NIPOMO COMMUNITY SERVICES DISTRICT

SPECIAL MEETING NOTICE & AGENDA SUPPLEMENTAL WATER PROJECT DESIGN & CONSTRUCTION COMMITTEE

REVIEW CONCEPT DESIGN REPORT

**RE: Constructability Review of AECOM Draft Design Report and Plans for the
NCSD Waterline Intertie Project**

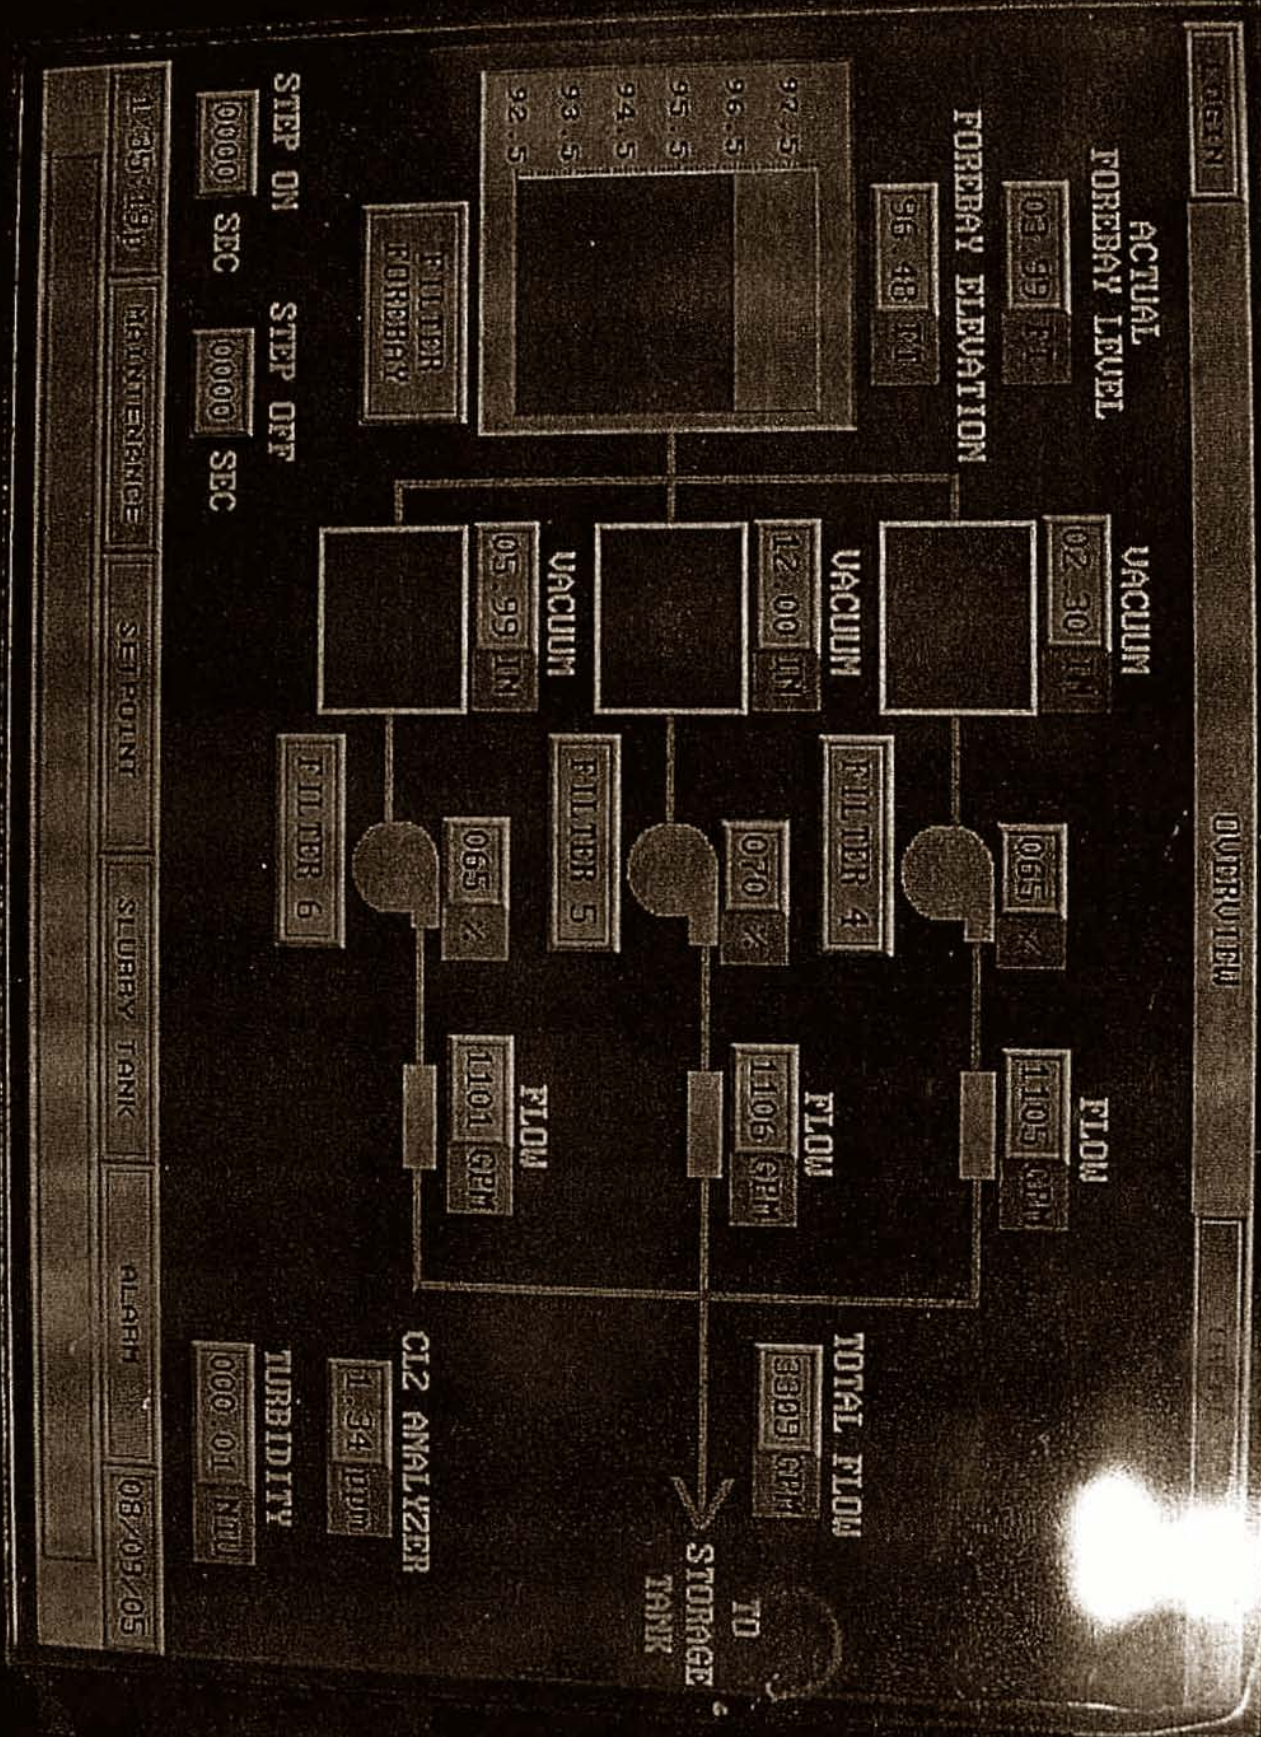
Note the attached image of the Lompoc WTP master filter control panel running three different pumps, each with different operating conditions. Fore bay set point 96.5 (actual at time of photo 96.48), three different pump vacuum conditions, each separate filter pump flow matched within 0.5%, (1105,1106,1101 GPM respectively) total flow of 3309 GPM to Clearwater reservoir using variable frequency drives and proportional integral derivative controller programming. Fore bay volume in above example is about 10,000 gallons, so control precision is very good. Given the level of precision attainable here, I think the 500,000 gallon reservoir "New Tank" is far larger than needed.
